Oct 31, 2012

RE: FCC ID: XYMPICO4A351WDC

Below, you may find our response, to your comments, sent Oct 22, 2012.

Figure 1: Typical frame structure - contention based mode

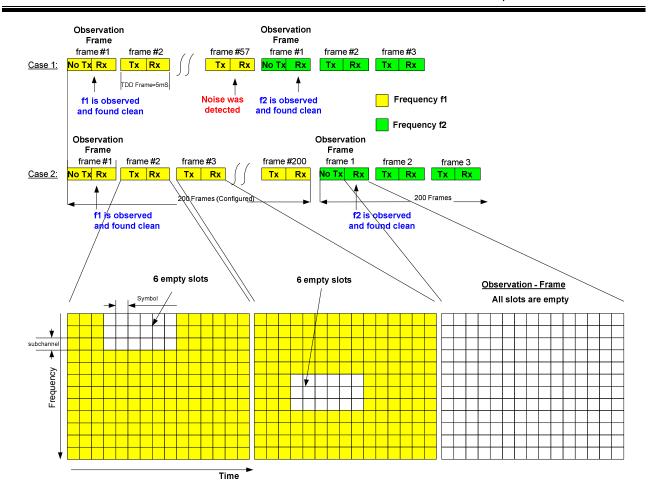
Q2: I am confused by the statement "In addition the system provides opportunity to other systems, by freeing the current frequency, every configured number of frames (default=200 frames=1sec) for configured number of frames (default=200)." How does this relate to: In case master detect noisy channel, it will stop transmitting immediately and look for another "clean" frequency. Freeing the frequency in 1 sec and immediately contradict each other.

Q3: Please provide some typical range of time values for "The BST always leaves empty slots, in each frame, for observing the channel".

A2: The opportunity procedure is performed in constant duration. Every 1 sec (configurable), the BST is freeing the frequency (fx) and transmit in another frequency (fy). It should be emphasized that the other frequency (fy) was checked that it is not busy. If (fy) found to be busy the BST will not transmit at (fy) and it will look after third frequency (fz) and so on.

The procedure described above doesn't relate to the case that the master is detecting noisy channel in its frame by frame measuring. As mentioned, the BST is measuring the noise every frame (frame =5msec) in special slots. If the BST detects noise, during this measurement, it will stop transmitting immediately. It will not wait for the opportunity procedure (1 sec) and will look after the next free frequency to transmit.

The following figure describes typical frame structure, in two cases:

Case 1 – interfering system was detected, while operating in frequency f1. Interference was detected on frame number 57. Immediately, on the next frame number 58, which is actually frame number 1, for frequency f2, base station listens to frequency f2. No transmission is made, on this frame, means this frame is used as observation frame, only. In case f2 is detected as clean frequency, base station will start transmission on the next frame. In case f2 is detected as busy frequency, base station will have additional observation frame, on frequency f3. This last case is not shown in the figure.

Case 2 – interfering system was not detected, throughout frequency f1 operation. On the next frame - number 1 of frequency f2 - base station listens to frequency f2. No transmission is made, on this frame. In case f2 is clean, base station will start transmission on the next frame – number 2.

A3: As shown in the figure, above, 6 empty slots are allocated, in each frame (frame=5msec). Slots are spreads over two dimensions (time and frequency domains, as defined by the OFDMA standard). Empty slots are span over 6 symbols (102Usec per symbol, 612Usec per 6 symbols), in time domain, and 3 subchannels (out of 35 Sub channels), in the frequency domain. Each subchannel consists of 1024 subcarriers, which represent all bandwidth, due-to permutation technique.
